# Technical Review Report for the Application for Contents Amendment for Shipping Isentropic Compression Experiment (ICE) Apparatus in 9977 Packaging

M. West

LLNL-TR-412981

Docket Number 09-05-9977

Figure 4-3 ICE Configuration in the 9977 (6CV)

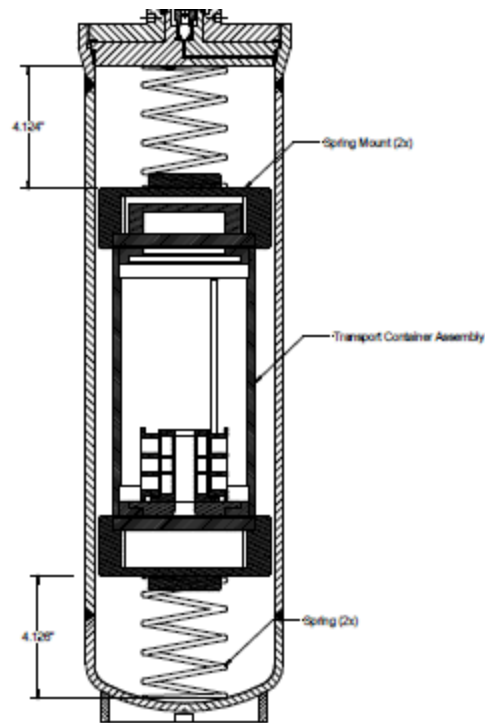
The ICE apparatus consists of a stainless steel assembly containing about 8 grams of <sup>239</sup>Pu or its dose equivalent as noted in Table 1, *Comparison of 9977 Content C.1 and the ICE Radioactive Contents*, of the Submittal. The ICE target is mounted on the transport container assembly base. A Viton<sup>®</sup> O-ring seals the transport container base to the transport container body. Another Viton<sup>®</sup> O-ring seals the transport container handle to the transport container body. The ICE apparatus weighs less than 30 pounds<sup>[6]</sup> and has less than 0.6 watts decay heat rate. For the Model 9977 Package, the maximum payload weight is 100 pounds and the maximum decay heat rate is 19 watts.<sup>[2]</sup> Thus, the maximum payload weight and the maximum decay heat rate for the Model 9977 Package easily bound those for the ICE apparatus. Figure 4-3, *ICE Configuration in the 9977 (6CV)*, and Figure 4-4, *Required Foam Within Coil Springs (Top Shown, Bottom Similar)*, are reproduced from the document, *9977 Containment Vessel Dynamic Response with ICE Payloads*.<sup>[6]</sup> The Figures show the packaging system, consisting of two spring mounts (6061-T6 aluminum), two springs formed from American Society for Testing and Materials (ASTM) A 288 QQW-470 steel music wire, and two square blocks of foam (Last-A-Foam<sup>®</sup> TF-5070-10 or equivalent) retained within the springs. The springs and blocks alone do not provide adequate damping for vibrations, arising from transportation, and the addition of foam energy-absorbing materials is necessary. In contrast, for the Model 9978 Package, Armaflex SA foam (a nitril-PCV blend) is used to cushion and to center the ICE assembly within the 5CV.<sup>[4]</sup>

Figure 4-4 Required Foam Within Coil Springs (Top Shown, Bottom Similar)

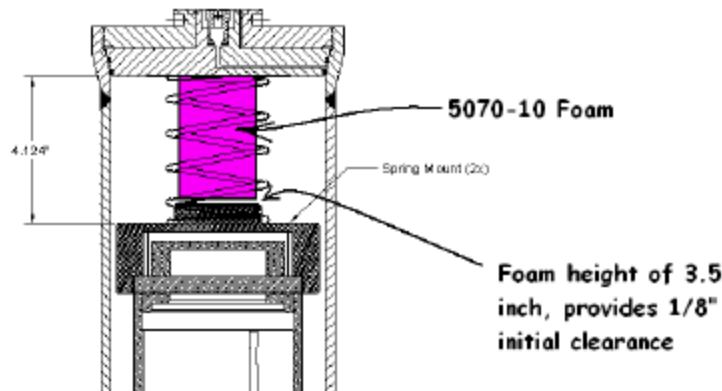
The ICE assembly requires a set of spring mounts, a set of springs, and a set of square blocks of foam, retained within the springs, in order to achieve adequate damping of vibrations during transportation in the 6CV for the Model 9977 Package.<sup>[6]</sup> However, the ICE assembly has to be an approved content configuration per Section 7.1.1.2, *Contents/Payload Preparation*, of the Model 9977 Package SARP in order to be loaded into that Packaging, so, there are no changes to Chapter 7 of the Model 9977 SARP.
